FIRE SAFETY INSPECTION REPORT

FAR EAST KNITTING AND DYEING INDUSTRIES, LTD. APEX ROAD

ACCORD
on Fire and Building Safety in Bangladesh

March 31, 2014

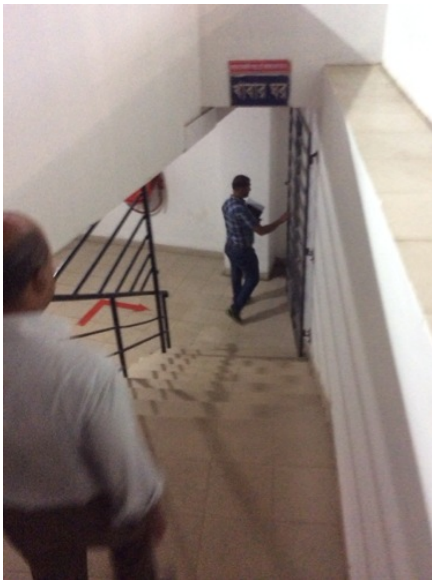
F-2	Fire Rated Construction	The boiler / generator room is not separated by fire-rated construction (openings, non-rated doors, penetrations).	Separate the boiler / generator room by a minimum 2-hr fire-rated construction. Seal and/or protected all openings to maintain the required fire separations	Within 3 months
		Ground floor		
F-3	Fire Rated Construction	Areas used for combustible storage are not separated by fire-rated walls.	Provide dedicated storage rooms separated by minimum 1-hr fire-rated construction.	Within 3 months
		2nd and 5th floors	Where separate storage rooms are not feasible, provide defined storage areas and limit the storage arrangement as follows: - Maximum height of 2.4m and maximum area of 23m² - If sprinkler protected: maximum height of 3.66m and maximum area of 93m² Separate areas of unenclosed combustible storage by a minimum clear distance of 3m.

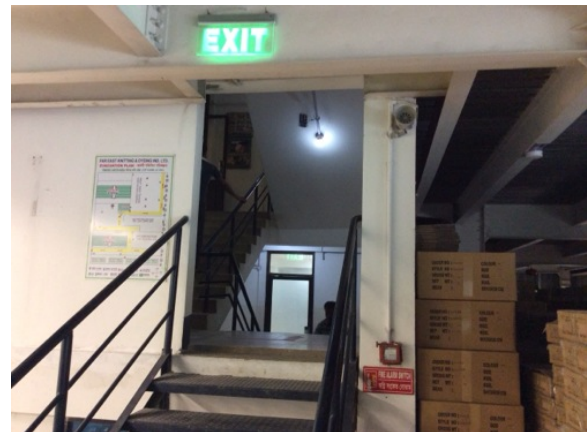
No.	Category	Finding	Recommendation	Remediation Timeframe
F-1	Fire Rated Construction	The exit stairs are not separated from work areas, and other spaces on each floor by fire-rated construction.	Provide minimum 1.5-hr fire rated doors and seal all unprotected openings to separate the exit stairs from work areas and other building spaces on all floor levels. Ensure that the fire doors are self-closing and positive latching and that they are provided with fire exit (panic) hardware where serving production floors. If fire doors are required to be held open for functional reasons, provide automatic-closing devices tied to the fire alarm system.	Within 3 months
